SERVICE BULLETIN

NUMBER: SB 500-53-003, REV A
MODEL: ECLIPSE EA500
SUBJECT: CORROSION PREVENTION

To prevent corrosion at outboard keel area.

**Stringer clips station 180.00–189.00
Figure 1**

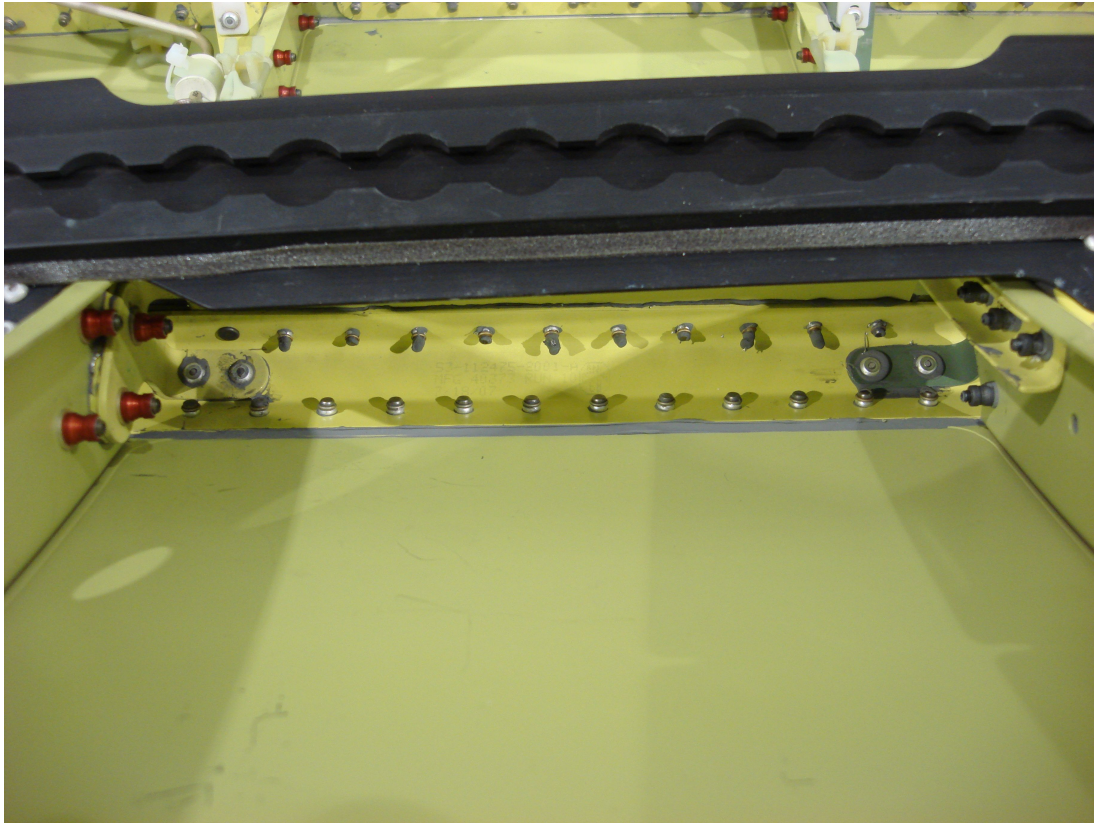
- (1) Locate left and right keel sheer tie at stringer six, frame station 180.00, and 189.00. See figure 1.
NOTE: Remove insulation as needed to gain access. Retain for reuse.
- (2) Area under keel sheer tie to be treated with a corrosion inhibitor. Located at fwd frame (sta. 180) on the lower frame flange is a production tooling hole see figure 2. Place nozzle from corrosion inhibitor into tooling hole facing aft and liberally coat area with Ardrox AV-15. The area to be coated is approximately from frame 180.00 to frame 189.00. Repeat for opposite side.
NOTE: Clean up excess corrosion inhibitor that may weep from keel area using clean lint free cloth and Install insulation if removed.
